PLANNING COMMISSION REGULAR MEETING

Tuesday, April 16, 2024 at 7:00 PM

AGENDA

3. SUP 2022-05 Warrenton Village Center, the Owners, Jefferson Associates LP and Warrenton Center, LLC with the Applicant, NewCastle Development Group, seek a Special Use Permit for two parcels totaling approximately 29.05 acres to create a mixed use development in the existing Warrenton Village Center. The proposal includes apartments, 2 over 2s, and townhomes with the addition of central plaza, parking garage, enhanced internal road network, and pedestrian infrastructure to promote walkability. The properties are zoned Commercial and designated in the New Town Character District of Plan Warrenton 2040. (GPINs 6985-20-7247 and 6984-29-6753)

SHEET NUMBER: **7**

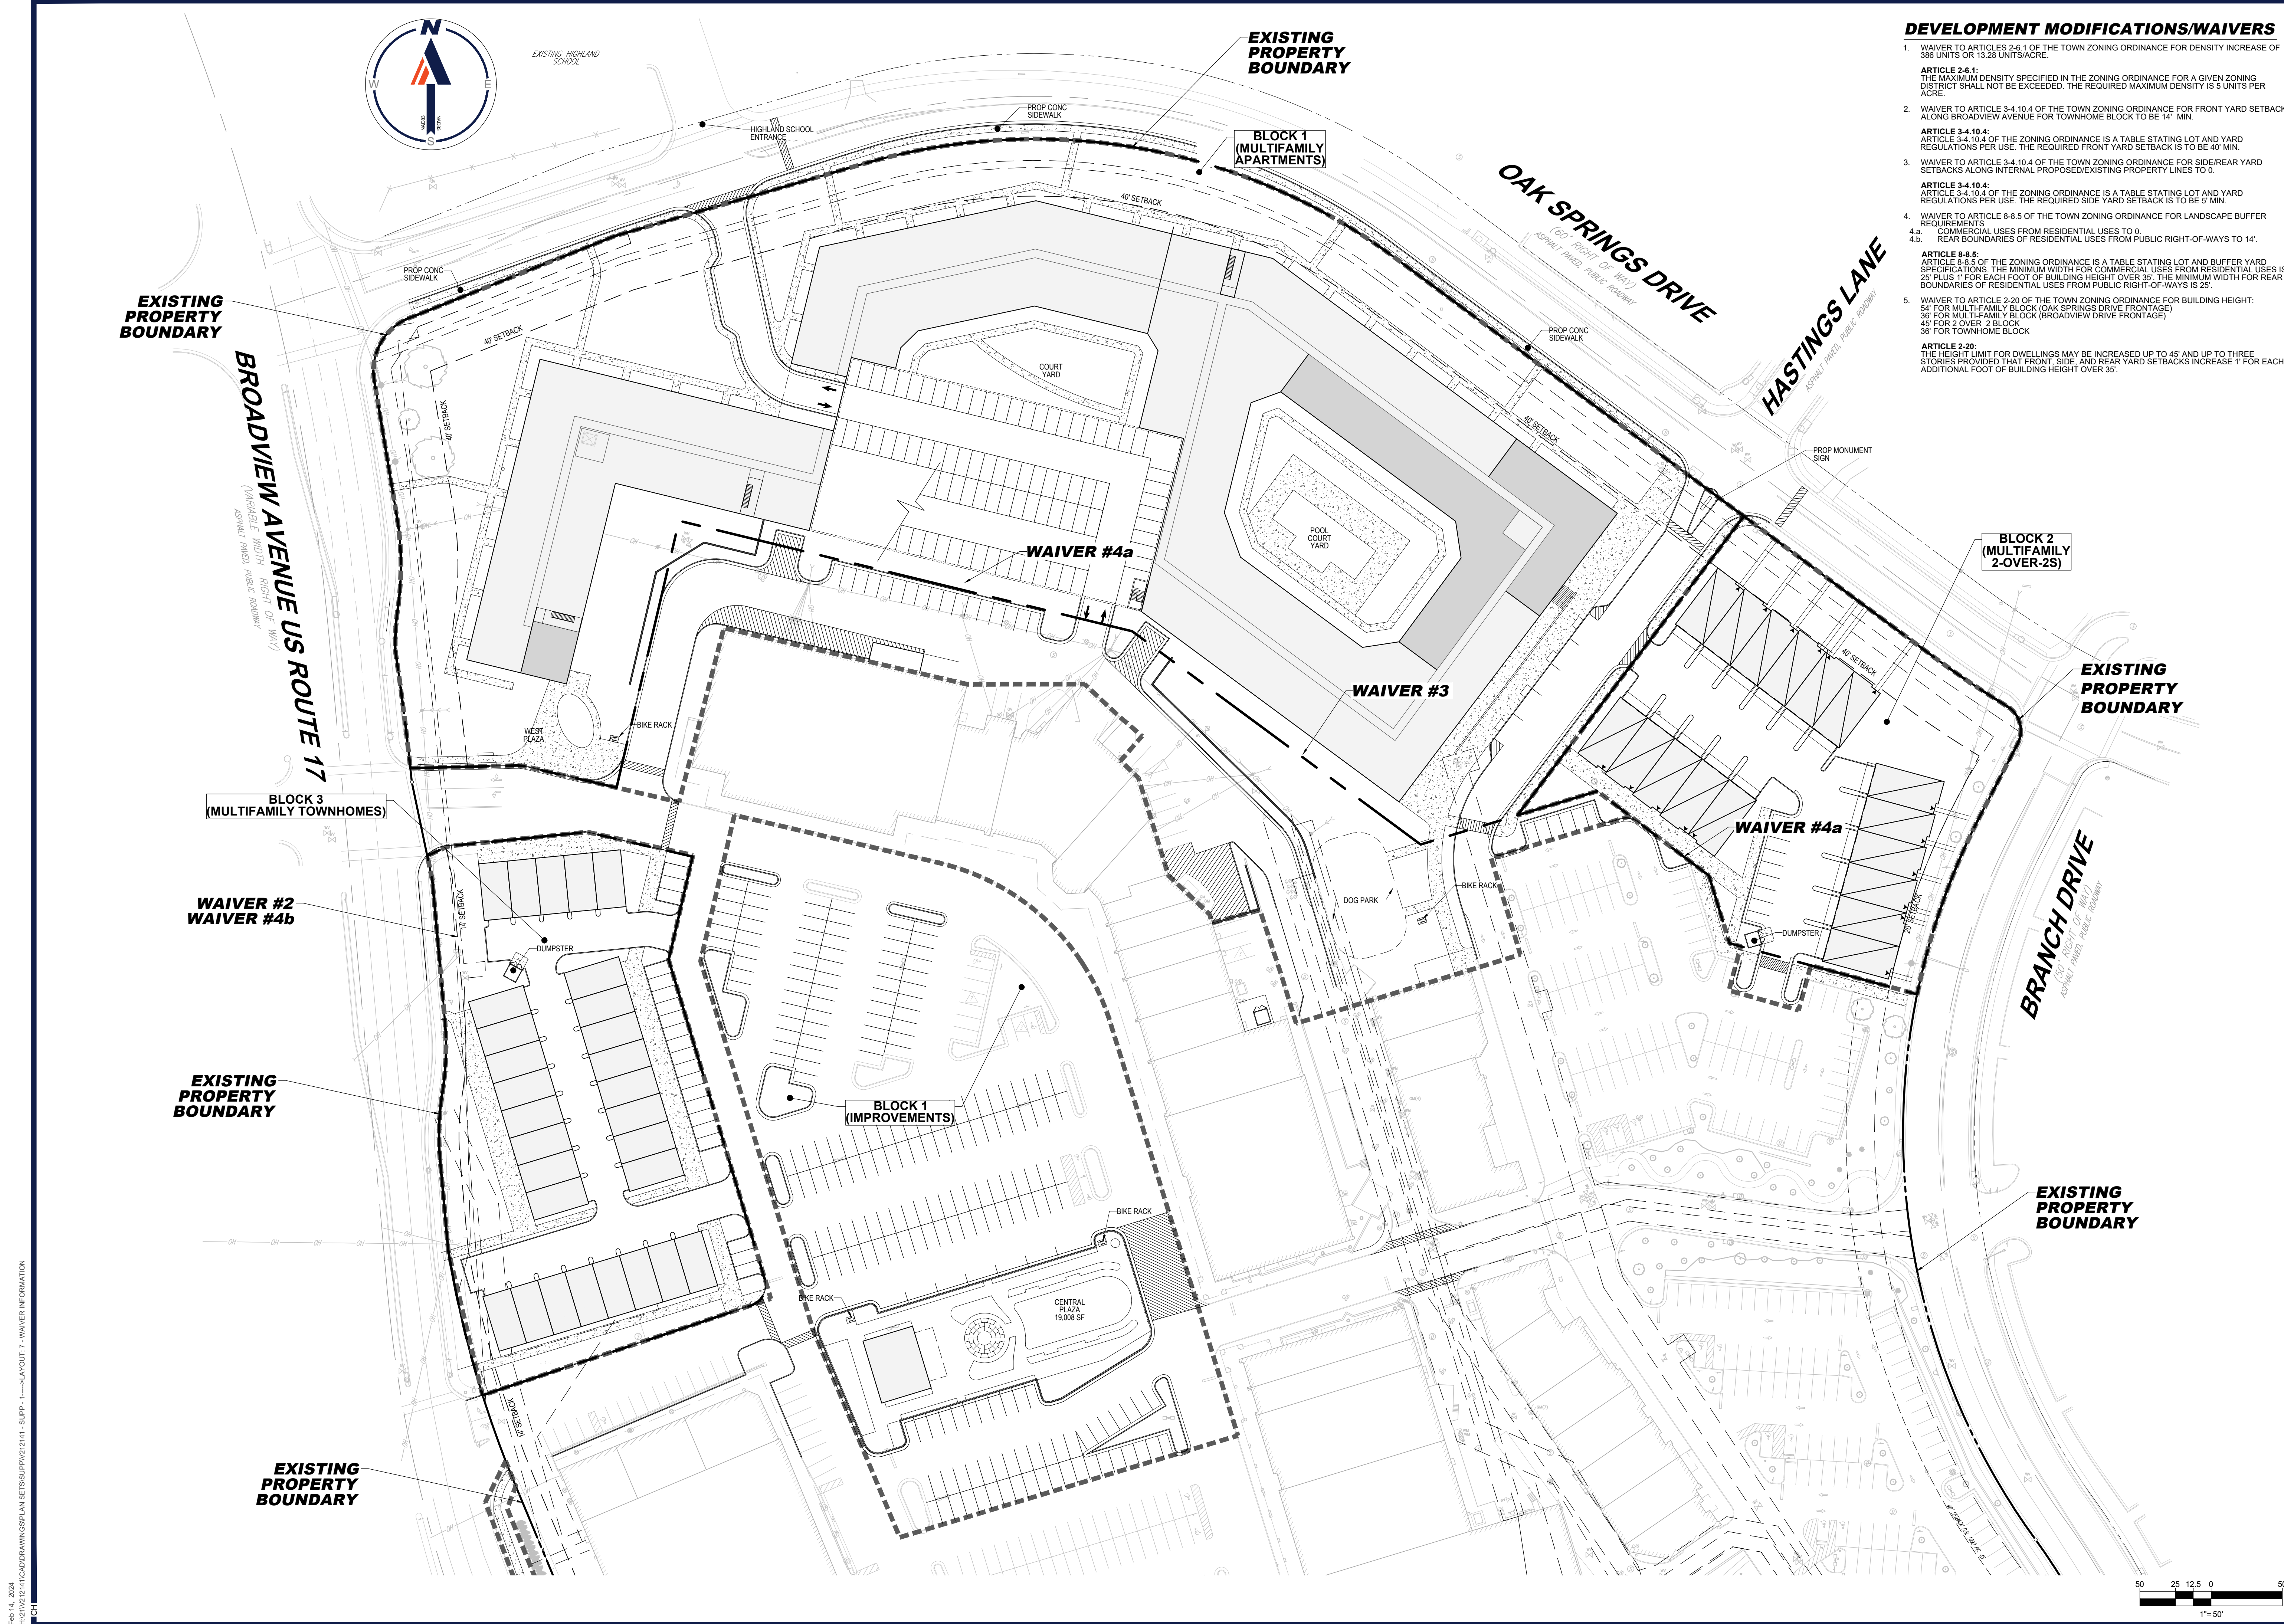
<p>To address the landscaping comments, staff requests that the plan set be revised to include a waiver/modification sheet that delineates those site areas where a waiver or modification is being requested, to include a comparison between the ordinance requirements and the proposed conditions.</p>	<p>Sheet 7 "Waiver Information" has been added to the SUP to define all waivers and illustrate the location of each waiver request.</p>

DEVELOPMENT MODIFICATIONS/WAIVERS

Figure 21: 2027 Future Conditions without Development – Level of Service Results

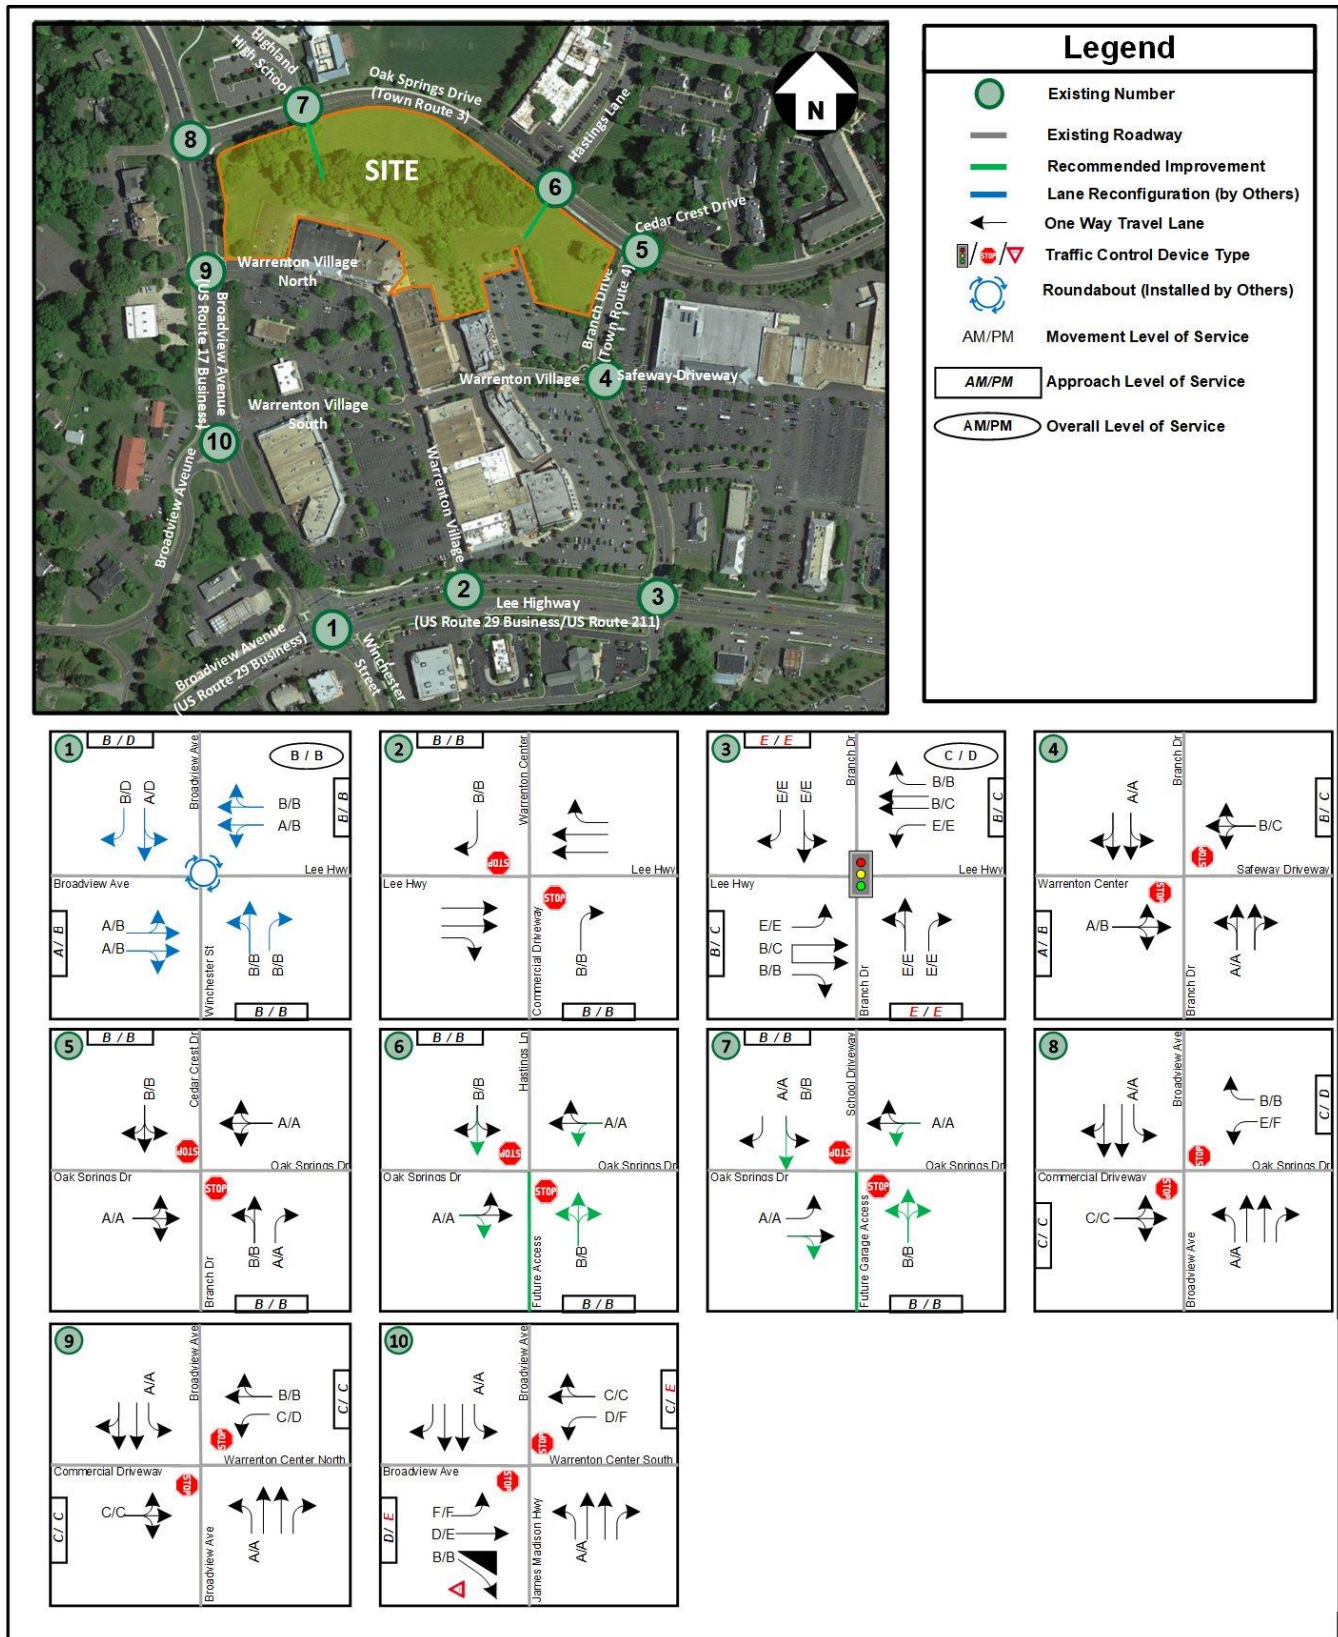
<p>Figure 19 - two AM peak hour volumes do not match the Synchro files (off by one vph): the northbound left turn at Intersection 5 and the westbound through movement at Intersection 7.</p>	<p>Volume figure has been updated to match the synchro</p>
<p>Please include the signal timing plans in the appendix.</p>	<p>Signal timing plans have been added to the appendix.</p>
<p>We recommend including a planning-level signal warrant analysis at Intersection 8.</p>	<p>A planning level signal warrant has been included.</p>
<p>We recommend evaluating a crosswalk crossing Oak Springs Dr at Intersection 7.</p>	<p>A crosswalk study will be submitted as a separate document.</p>
<p>We recommend evaluating left turn lanes on northbound and southbound Branch Dr at Intersection 4.</p>	<p>Left and right turns were evaluated and discussed in the report. The existing volumes warrant a northbound left turn lane.</p>
